DIGICO
RÉSEAU GLOBAL INC.
GLOBAL NETWORK INC.

| Subject | Client | | McGill Cosmology | # | 13090 |
| | Assem bly # | Cryoelectronics Rev0A | PCB | Cryoelectronics Board Rev0 | |

NPI Non-conformity Report

Image 2

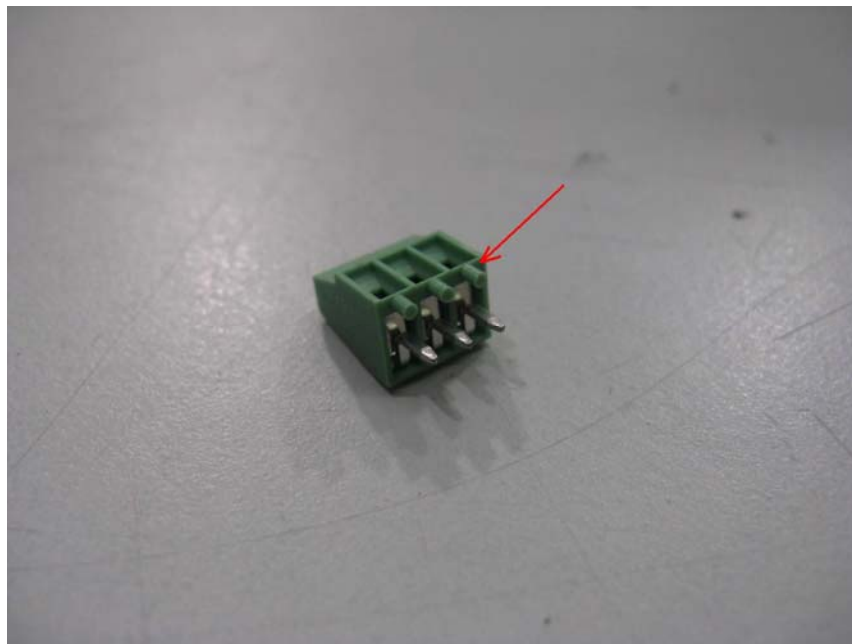
| No | Non-conformity | Suggested Solution | Impact | Customer Feedback |
|----|---|------------------------------------|--------------|-------------------|
| 6 | Mismatch component – footprint J4 & J11 | Review PCB design or component | Productivity | |

6. The terminal blocks J4 and J11 have guiding pins, Image 2, but the PCB does not have holes for those pins. The guiding pins have been removed upon customer's approval.

Image 3

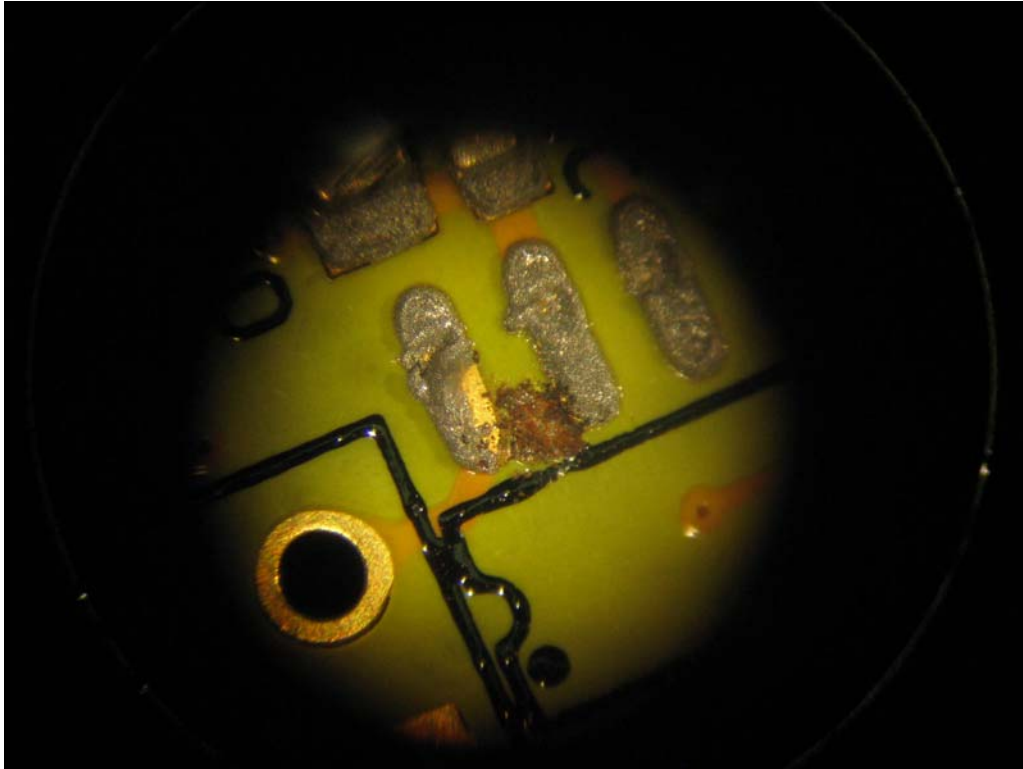
| No | Non-conformity | Suggested Solution | Impact | Customer Feedback |
|----|---|------------------------------------|--------------|-------------------|
| 8 | Solder mask issue on one PCB | Notify supplier | Reliability | |

7. The yellow solder mask does not allow for proper AOI inspection of the solder joints.
8. One of the PCBs has an imperfection between the pads of O3U4, see Image 3. The solder mask is missing and there is some unknown particulate matter instead. There does not seem to be any circuitry in the affected area and the two pads

are not shorted, so the PCB was populated with customer's agreement. The serial number of the affected product is 14090001.
